AGENDA
CONCEPTUAL PLAN REVIEW COMMITTEE
Community Room, 3rd Floor
Arlington Heights Village Hall, 33 S. Arlington Heights Rd.
Arlington Heights IL 60005
March 12, 2025
6:30 PM

VILLAGE OF ARLINGTON HEIGHTS **STAFF DEVELOPMENT** **COMMITTEE REPORT**

Temp File Number: T1874
Project Title Amazon Additional Buildings
Address: 1455 Cellular Dr.
PIN: 03-07-100-015-0000

Temp File Number: T1750
Project Title: S. Arlington Heights Rd. Townhomes
Address: 1501-1505 S Arlington Heights Rd.
PIN: Multiple Pins

OVERALL SITE PLAN

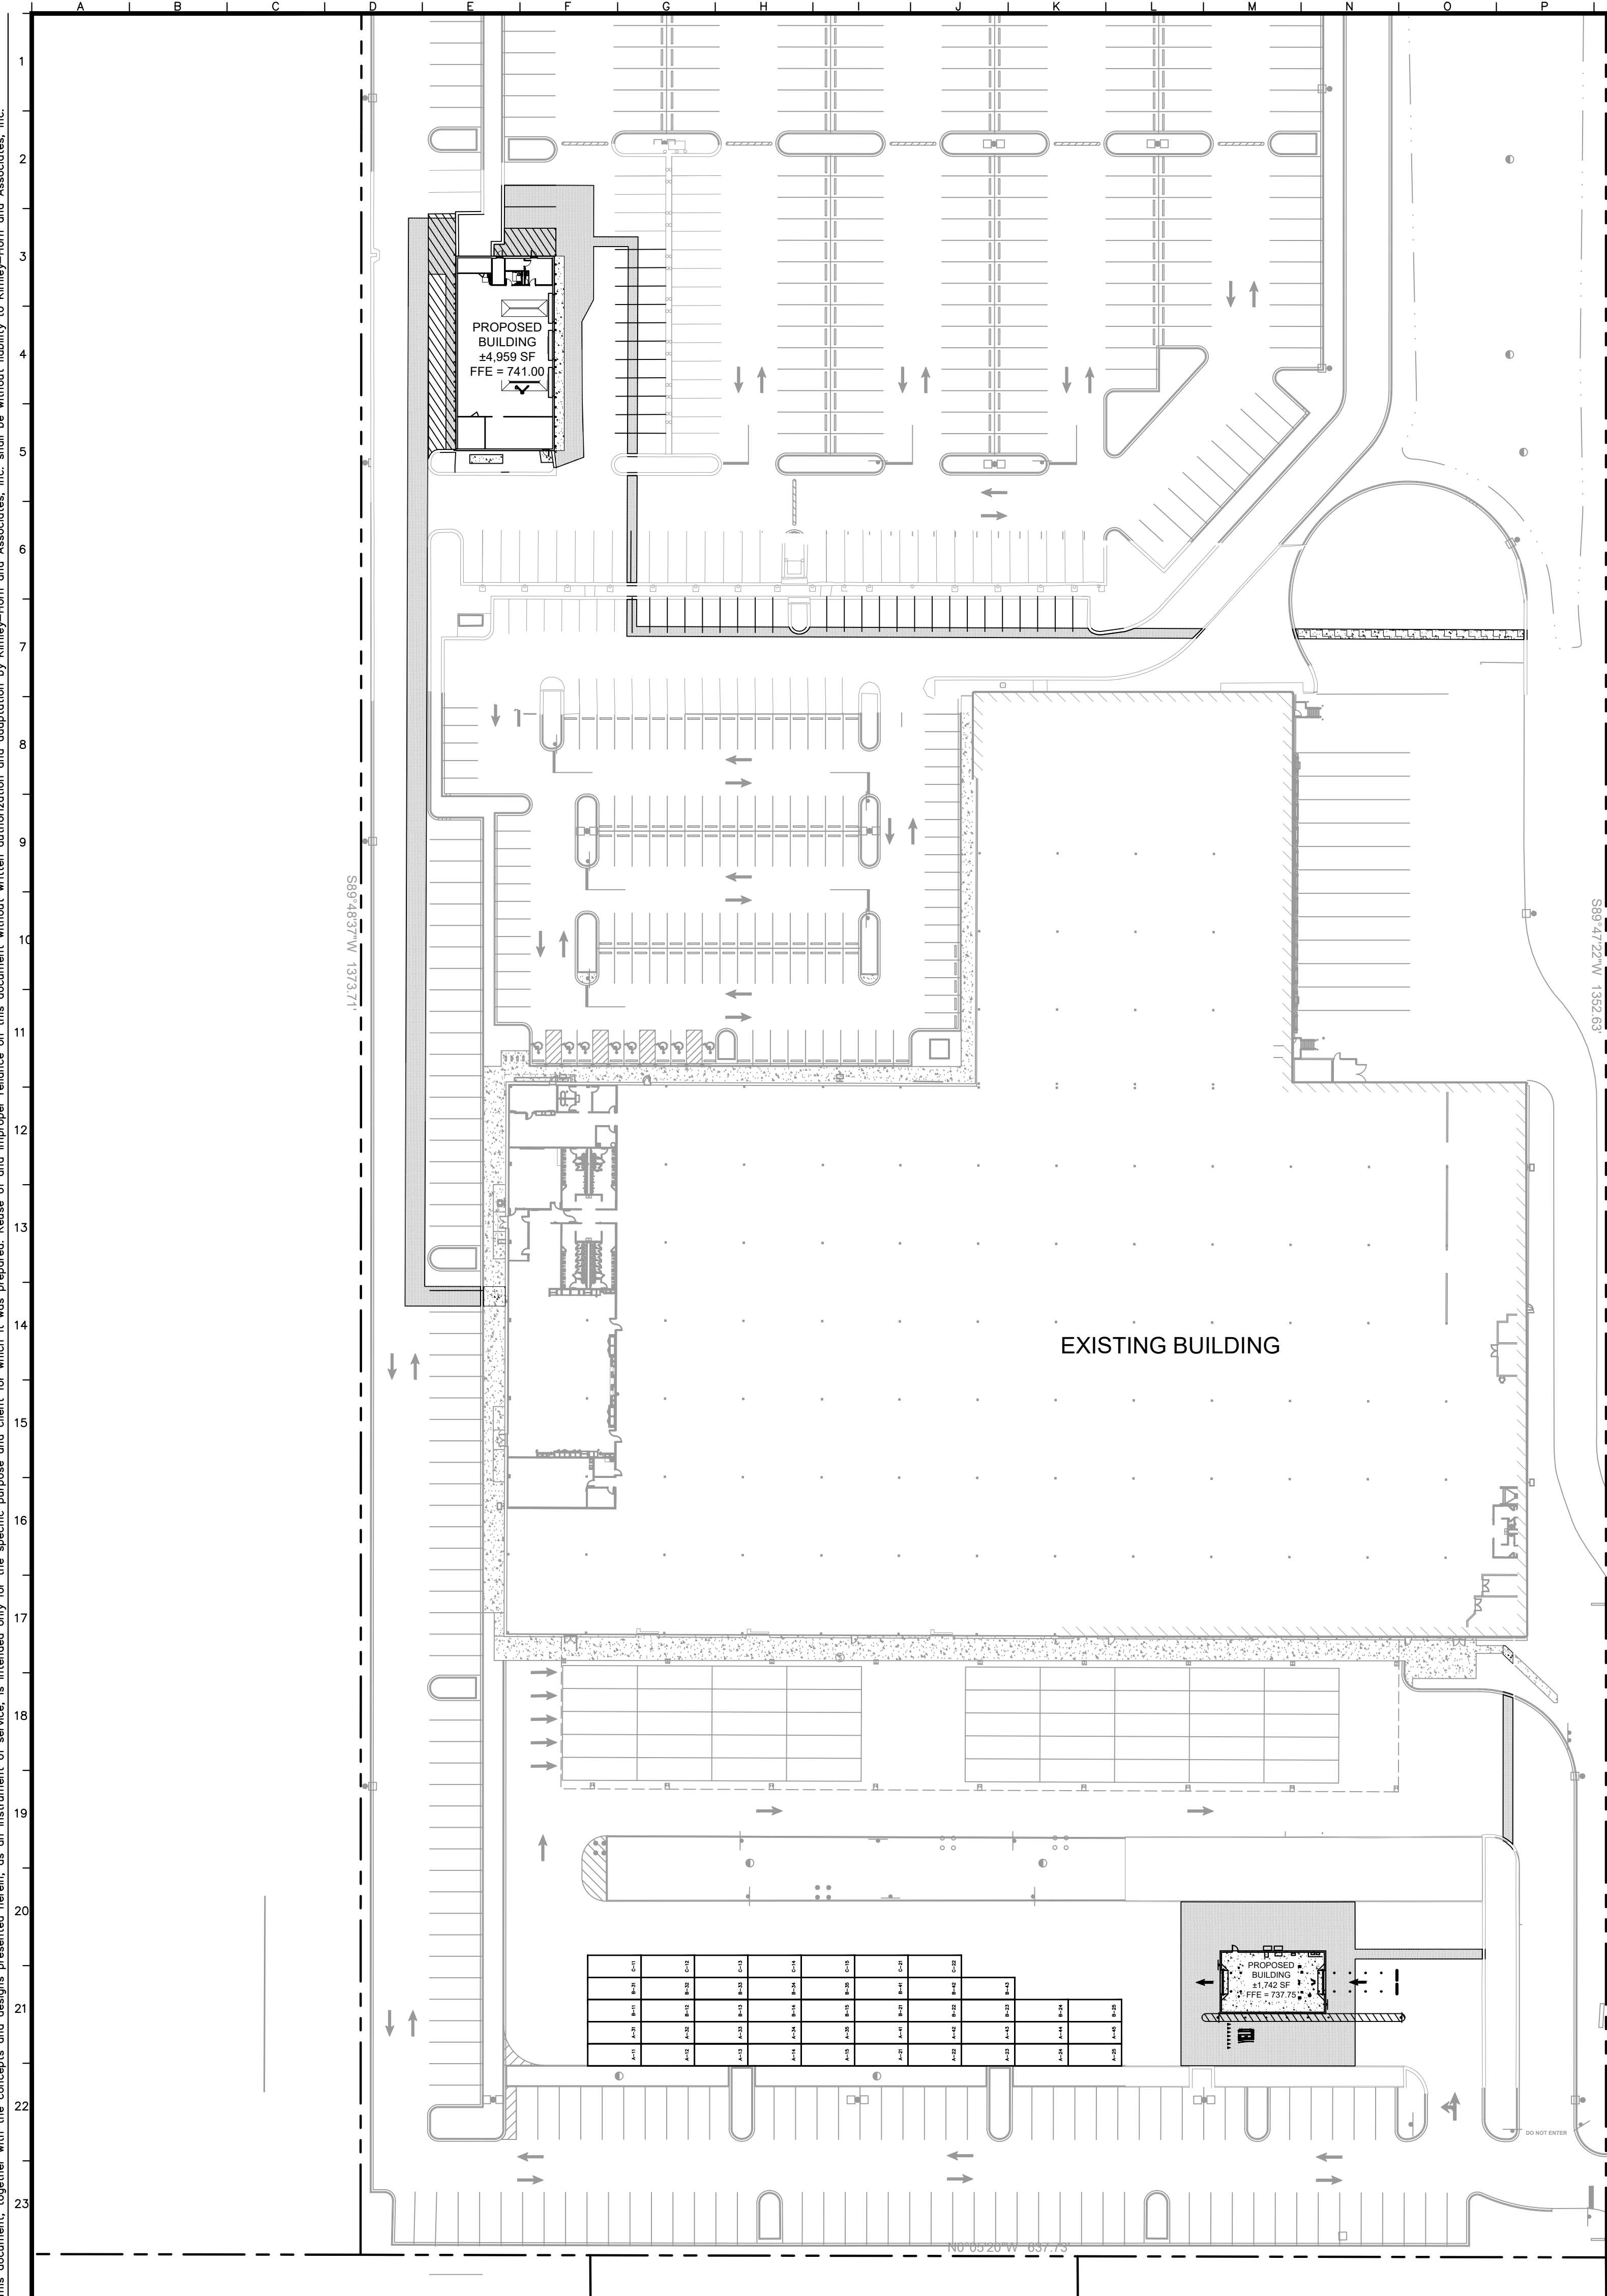
1. A detailed parking survey shall be provided, which surveys existing parking demand and capacity during a 3-day period.
2. Petitioner will need to provide details on the chemicals or flammable liquid storage in either facility.
3. Petitioner will need to provide information on any electrical vehicle charging in either facility.

1. A detailed parking survey shall be provided, which surveys existing parking demand and capacity during a 3-day period.
2. Petitioner will need to provide details on the chemicals or flammable liquid storage in either facility.
3. Petitioner will need to provide information on any electrical vehicle charging in either facility.

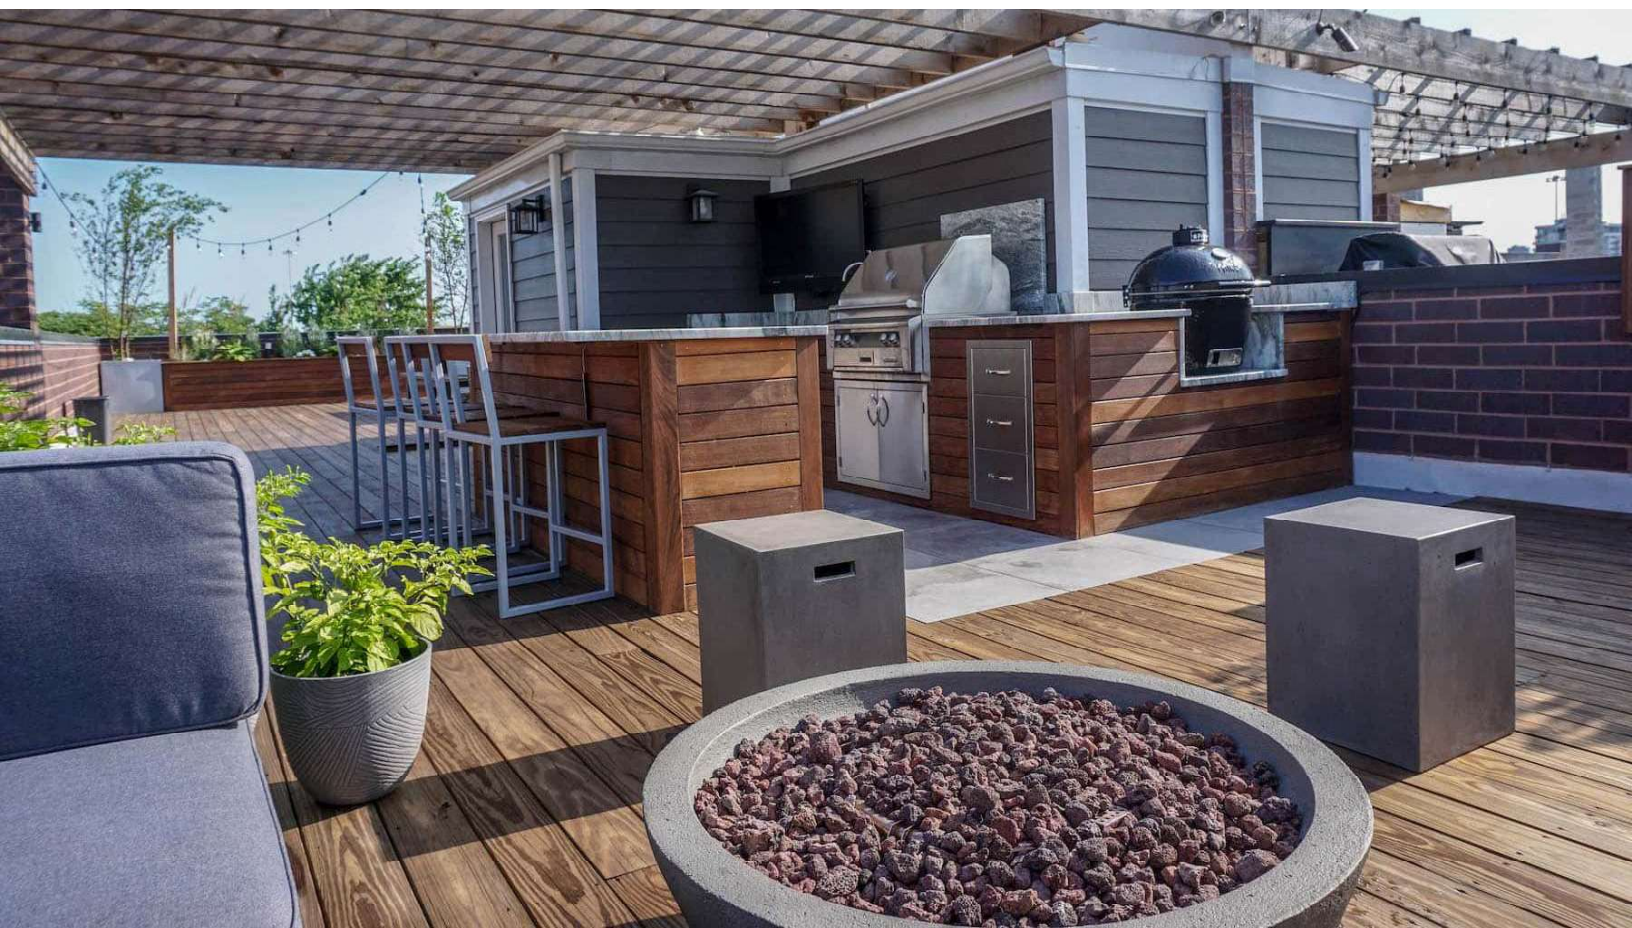
7. Consider a less dense site to provide more open space.
8. Density calculations must be provided with Plan Commission Application
9. Properties along the eastern side of Arlington Heights Road between Noyes Street and Council Trail have been developed with front yard setbacks on Arlington Heights Road that are approximately 100'. The southwest building(s) should maintain the same setback as the northwest building.

22. A full traffic study will be required.
23. Petitioner should evaluate providing a second access to the site to Noyes Street through the NW Gastroenterologist Lot 2. This may require modifications to the existing detention basin for the NW Gastroenterologist site.

26. An Auto Turn exhibit will be required using Tower Ladder 133.
27. Approved fire apparatus access roads shall be provided for every facility, building or portion of a building hereafter constructed or moved into or within the jurisdiction. The fire apparatus access road shall comply with the requirements of this section and shall extend to within 150 feet (45 720 mm) of all portions of the facility and all portions of the exterior walls of the first story of the building as measured by an approved route around the exterior of the building or facility. Please provide documentation showing compliance with this section of the code.

28. Where the vertical distance between the grade plane and the highest roof surface exceeds 30 feet (9,144 mm), approved aerial fire apparatus access roads shall be provided. For purposes of this section, the highest roof surface shall be determined by measurement to the eave of a pitched roof, the intersection of the roof to the exterior wall, or the top of parapet walls, whichever is greater. Please provide documentation showing compliance with this section of the code.

29. Aerial fire apparatus access roads shall have a minimum unobstructed width of 26 feet (7925 mm), exclusive of shoulders, in the immediate vicinity of the building or portion thereof. Please provide documentation showing compliance with this section of the code.

30. One or more of the required access routes meeting this condition shall be located not less than 15 feet (4572 mm) and not greater than 30 feet (9144 mm) from the building, and shall be positioned parallel to one entire side of the building. The side of the building on which the aerial fire apparatus access road is positioned shall be approved by the fire code official. Please provide documentation showing compliance with this section of the code.
